## Addendum

<i>Project Number</i> LGA Project No. 21074	<i>Client / Project Title</i> A New School Facility: Horace Maynard Middle School
<i>Addendum Number</i> Addendum 008	<i>Date</i> Monday, June 24, 2024
<i>Addendum Compiled By</i> Paul M. McCall AIA, Lewis Group Architects – <a href="mailto:pmccall@lewisgroup.net">pmccall@lewisgroup.net</a>

# Exhibit A: Horace Maynard Middle School Football Grandstand Footings Design

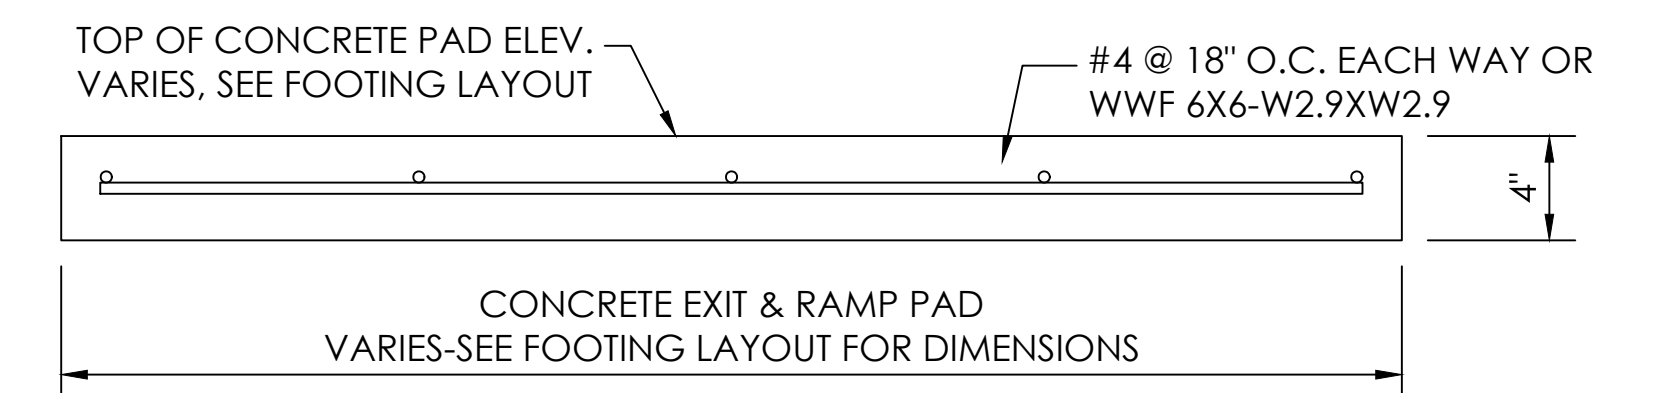
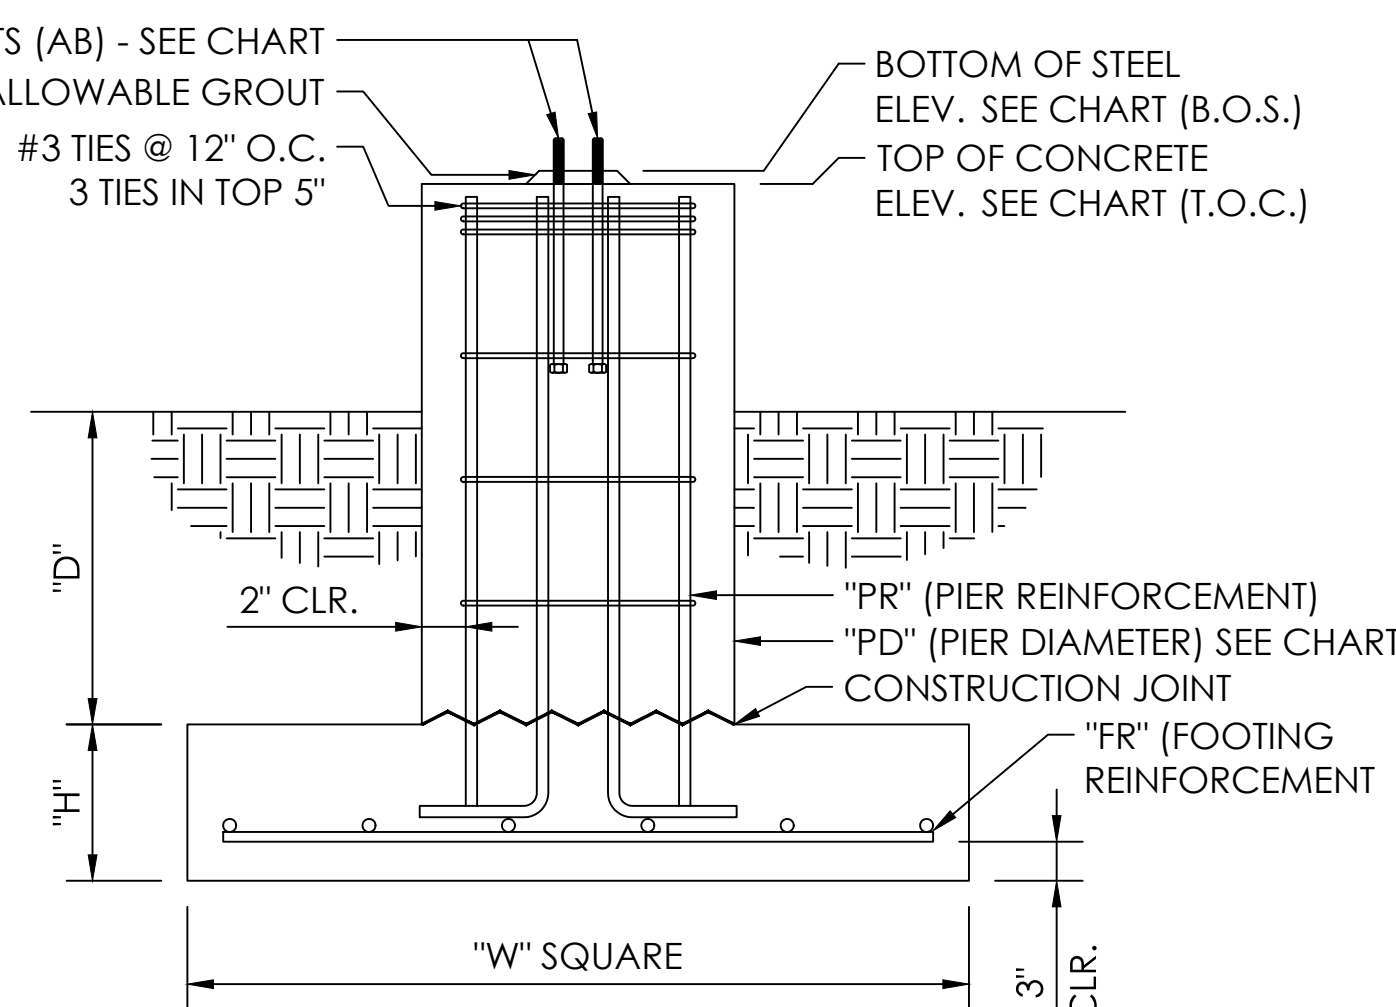
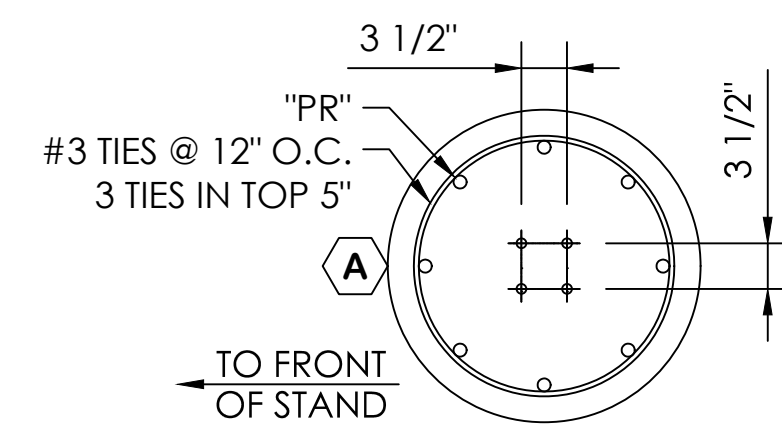
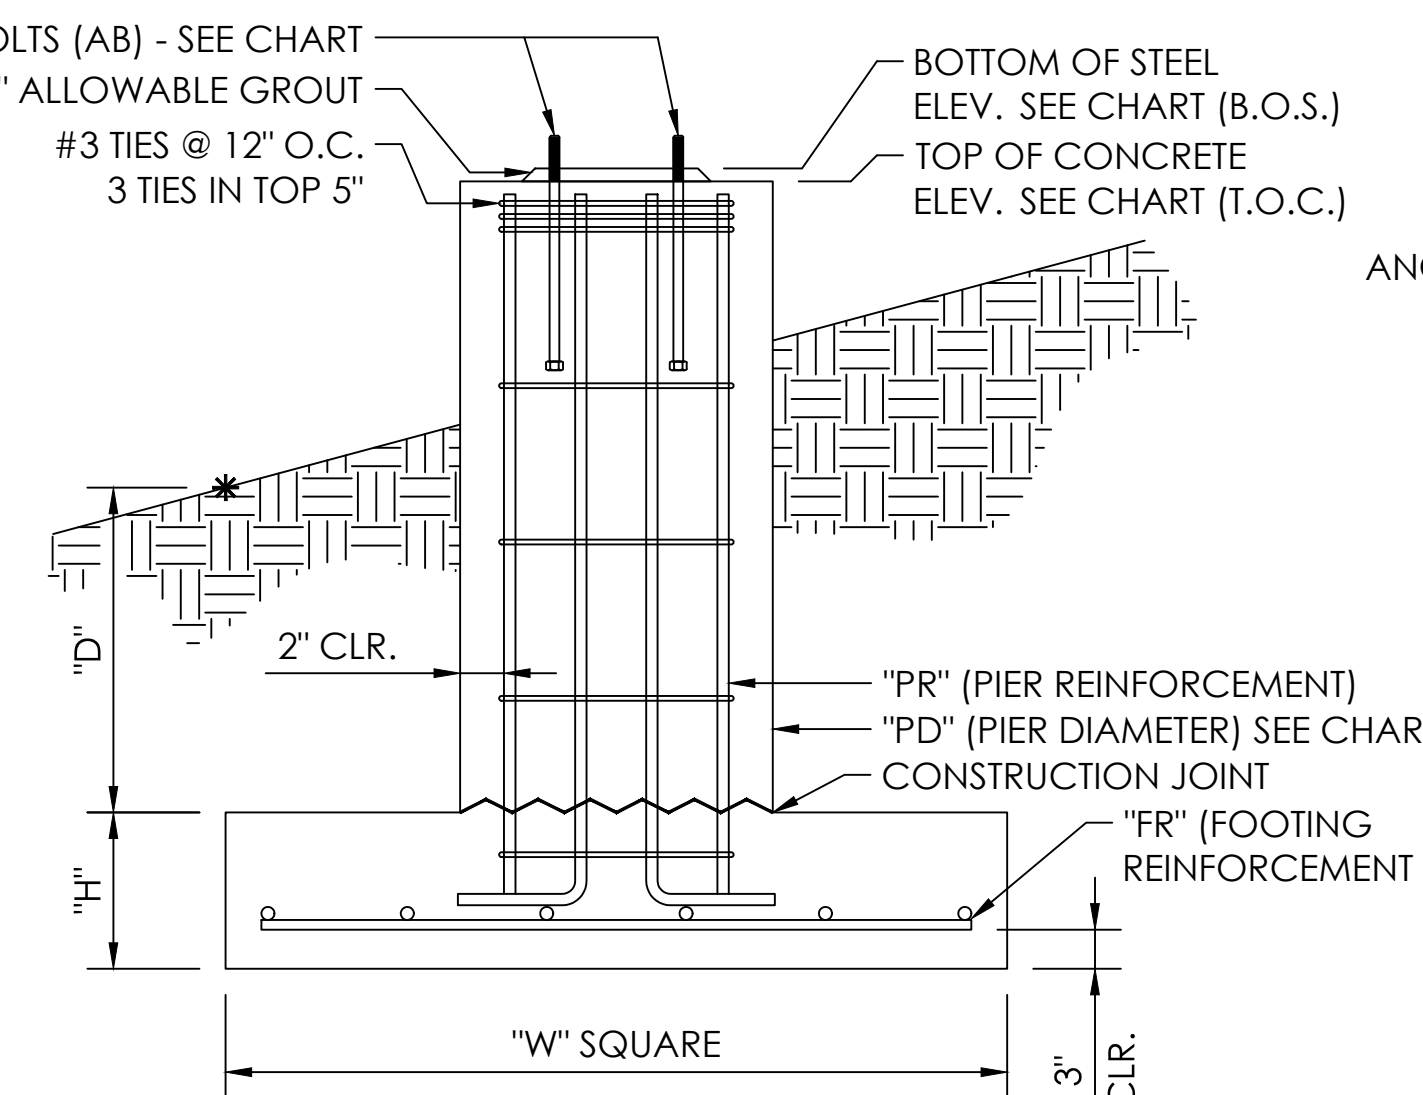
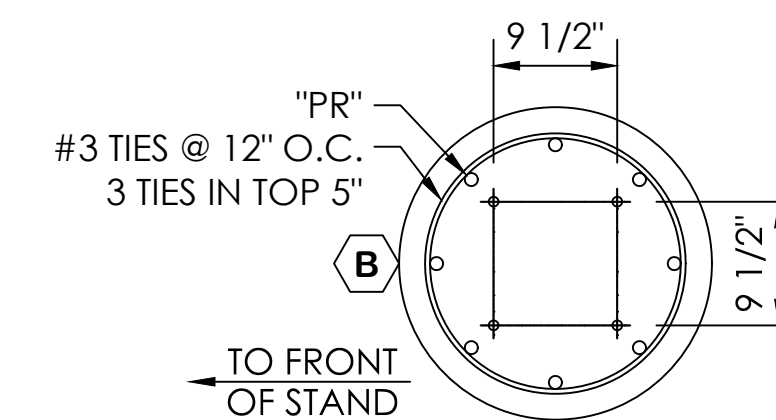
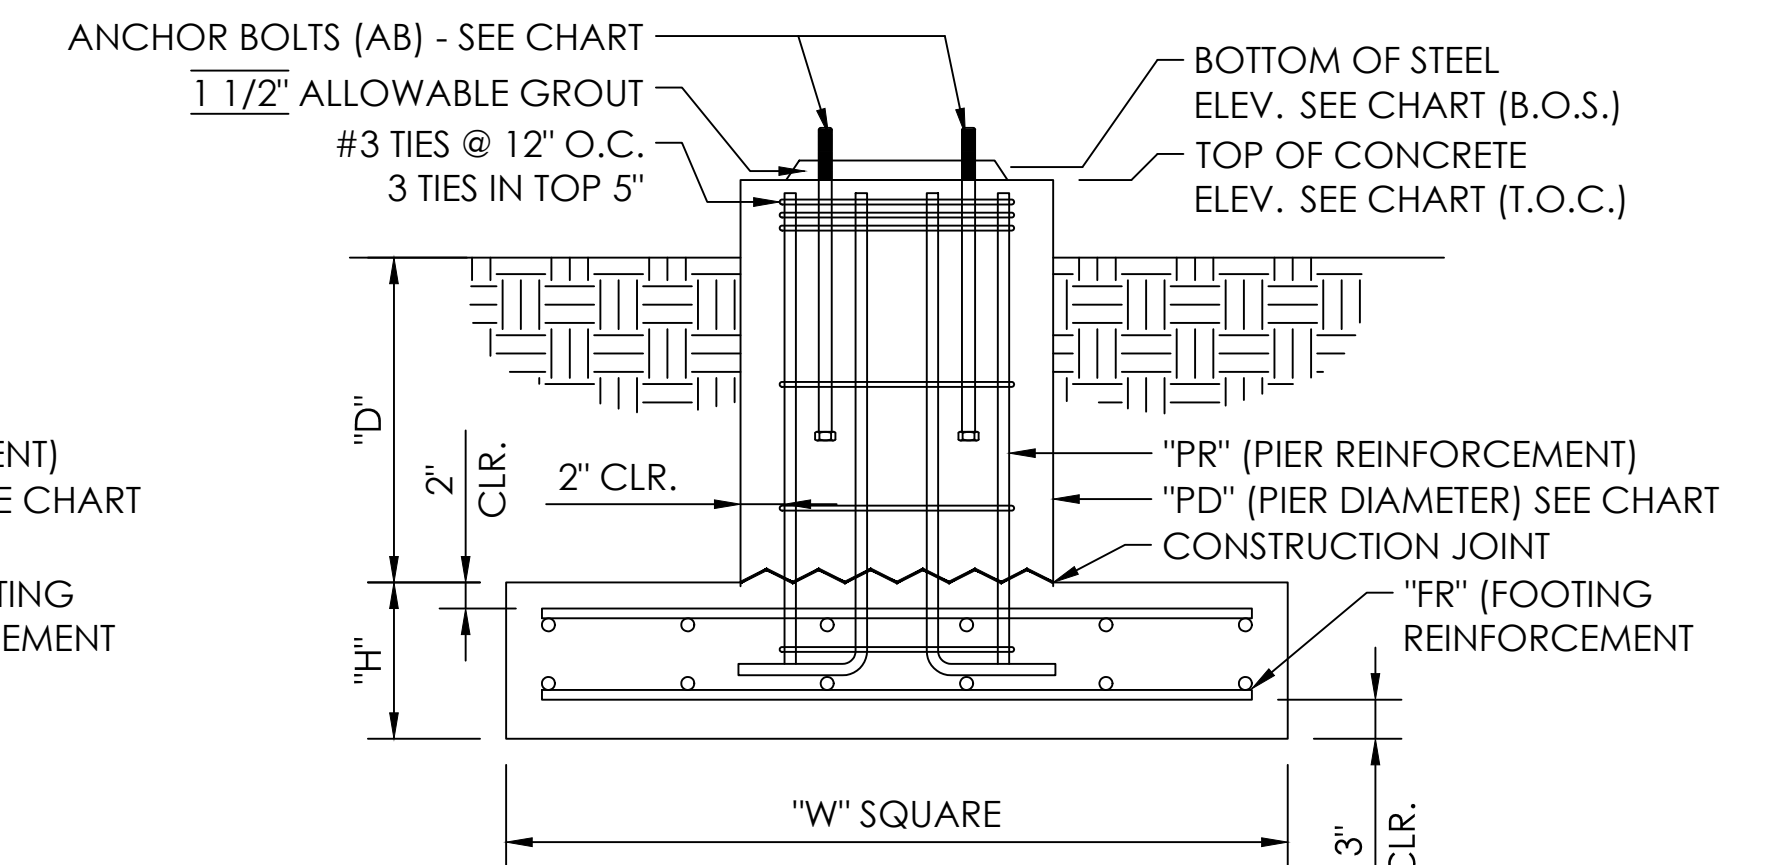
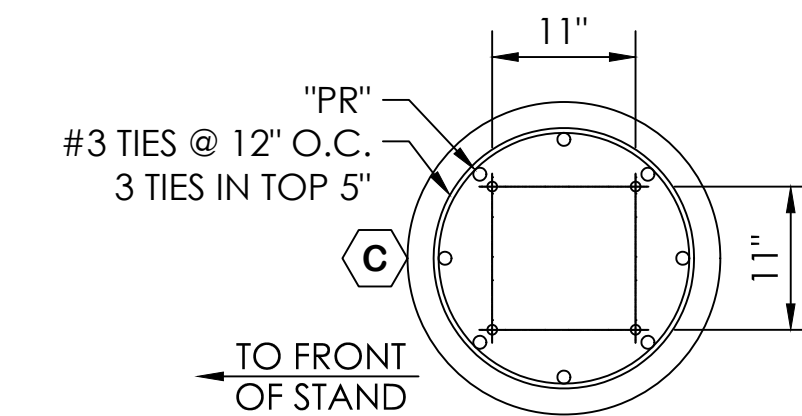
12. RFI #03 - AS1.13: The Grandstand vendors are excluding all concrete work. The foundation requirements for the Grandstands are not listed on the drawings. Please provide foundation design requirements for the Grandstands. **ANSWER:** *The design of the Grandstand footings are the responsibility of the Grandstand manufacturer, while the construction of those footings are the responsibility of the GC/ concrete subcontractor. It is a delegated design and must be stamped by a Tennessee-licensed structural engineer. For bidding purposes, the basis-of-design manufacturer has provided a drawing for the typical bleacher footings. That drawing is included in this addendum as "Exhibit A", and titled "Horace Maynard Middle School Football Grandstand Footings Design".*

FOOTING SCHEDULE							
"D" (DEPTH OF PAD)	"H" (THICKNESS OF PAD)	"W" (WIDTH OF PAD)	"FR" (FOOTING REINFORCEMENT)	"PR" (PIER REINFORCEMENT)	"PD" (PIER DIAMETER)	"AB" (ANCHOR BOLTS)	T.O. FTG. ELEV.
2'-0"	1'-3"	8'-0" SQUARE	(11)-#5 BOTH WAYS	(8)-#7 VERT.	24"Ø	(4)-3/4" X 18" HEADED ANCHOR BOLTS	N/A.
